PCI-SIG ENGINEERING CHANGE NOTICE

TITLE:	Surprise Down Error & Link Up Additions
DATE:	4 Feb 2004 (updated 10 June 2004)
AFFECTED DOCUMENT:	PCI Express Base Specification Revision 1.0a
SPONSOR:	David Harriman, Intel Corporation

Figure 7-16: Link Capabilities Register

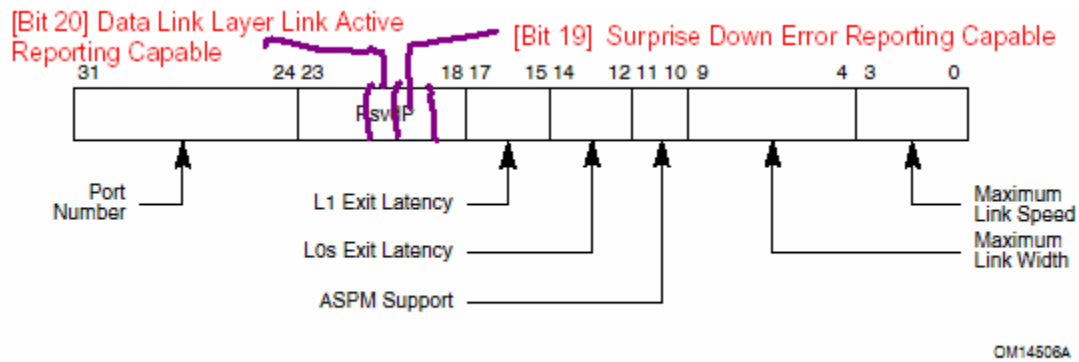
Bit Location	Register Description	Attributes
...		
17:15	...	
<u>19</u>	<u>Surprise Down Error Reporting Capable – For a Downstream Port, this bit must be set to 1b if the component supports the optional capability of detecting and reporting a Surprise Down error condition.</u> <u>For Upstream Ports and components that do not support this optional capability, this bit must be hardwired to 0b.</u>	<u>RO</u>

Bit Location	Register Description	Attributes
<u>20</u>	<p><u>Data Link Layer Link Active Reporting Capable</u> – For a Downstream Port, this bit must be set to 1b if the component supports the optional capability of reporting the DL_Active state of the Data Link Control and Management State Machine.</p> <p>For Upstream Ports and components that do not support this optional capability, this bit must be hardwired to 0b.</p>	<u>RO</u>
31:24	...

Figure 7-18: Link Status Register

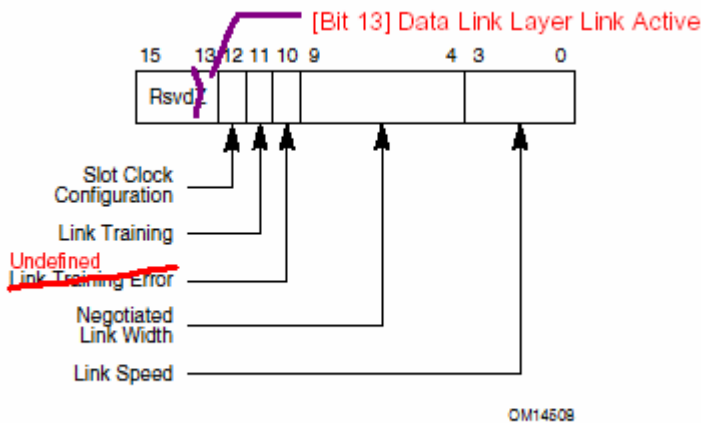
In 7.8.8, Link Status Register (note: preceding ECN removing Training Error reflected in the markups below):

Bit Location	Register Description	Attributes
...		
<u>13</u>	<p><u>Data Link Layer Link Active (Optional)</u> – Set to 1b when the Data Link Control and Management State Machine is in the DL_Active state, 0b otherwise.</p> <p>If this optional status reporting capability is not implemented, this bit must be hardwired to 0b.</p>	<u>RO</u>

Figure 7-28: Uncorrectable Error Status Register

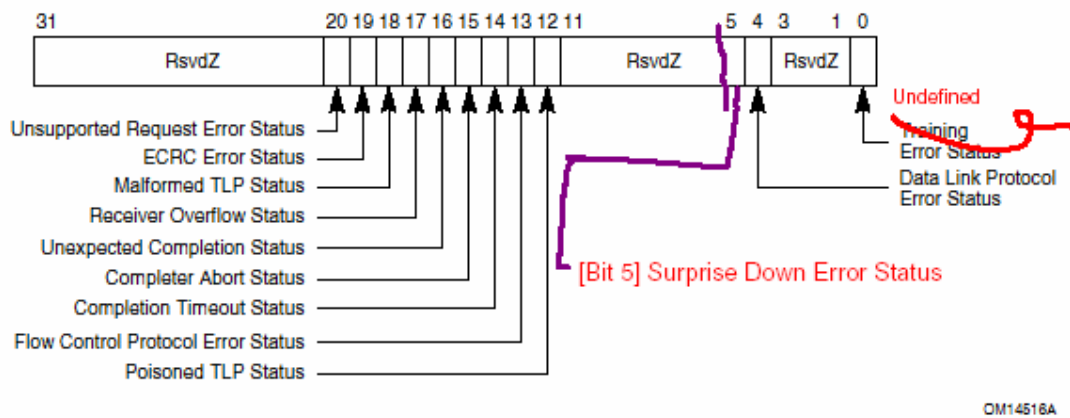
In 7.10.2, Uncorrectable Error Status Register (note: preceding ECN removing Training Error reflected in the markups below):

Bit Location	Register Description	Attributes	Default Value
...			
<u>5</u>	<u>Surprise Down Error Status (Optional)</u>	<u>RW1CS</u>	<u>0</u>
...

Figure 7-29: Uncorrectable Error Mask Register

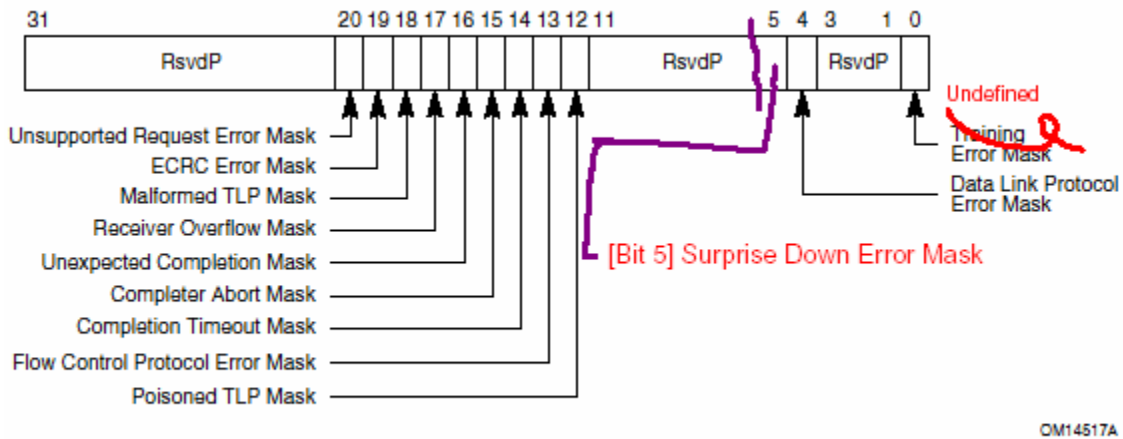
In 7.10.3, Uncorrectable Error Mask Register (note: preceding ECN removing Training Error reflected in the markups below):

Bit Location	Register Description	Attributes	Default Value
...			
<u>5</u>	<u>Surprise Down Error Mask (Optional)</u>	<u>RWS</u>	<u>0</u>
...

Figure 7-30: Uncorrectable Error Severity Register

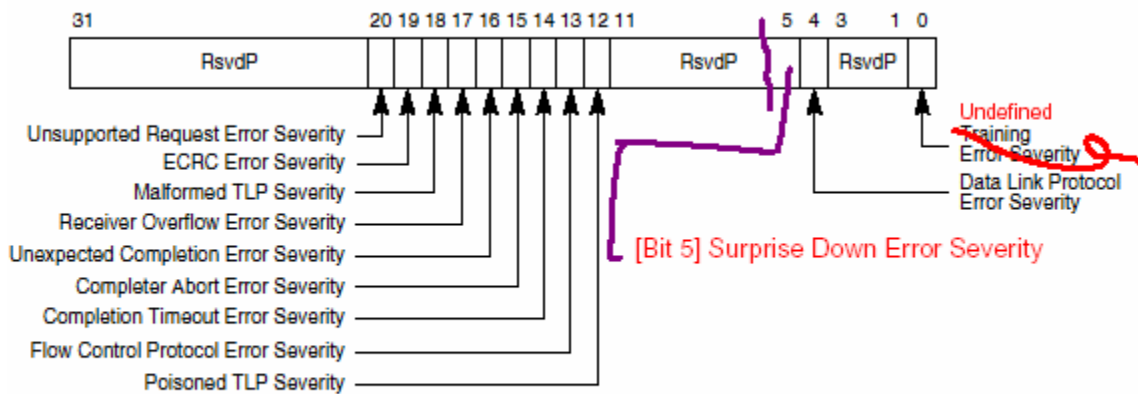
In 7.10.4, Uncorrectable Error Severity Register (note: preceding ECN removing Training Error reflected in the markups below):

Bit Location	Register Description	Attributes	Default Value
...			
<u>5</u>	<u>Surprise Down Error Severity (Optional)</u>	<u>RWS</u>	<u>1</u>
...
